X-TYPE

XT303-S937

TECHNICAL BULLETIN

Enhancements To Vehicle Operation – Reprogram ECM/TCM – Service Action S937 MODEL 2002-03 MY X-TYPE

ILLUSTRATION 1

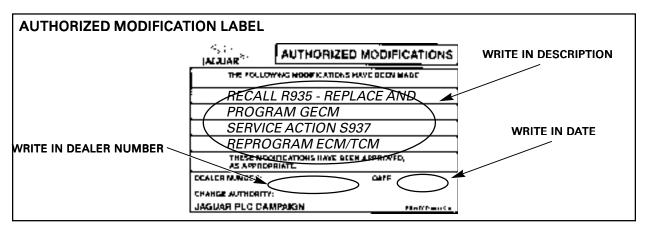
- 4. Select and run 're-configure existing ECM' application.
- 5. After reconfiguration of ECM is complete, return to configuration main menu.
- 6. On automatic transmission vehicles, select and run 're-configure existing TCM' application.
- 7. On all vehicles, after reconfiguration of ECM/TCM is complete, switch 'OFF' PTU, disconnect from vehicle, and return WDS to original location.
- 8. Fill out an authorized modification label (Illustration 1) and apply it to the underside of the hood. This information can be written on the same label being used for R935.
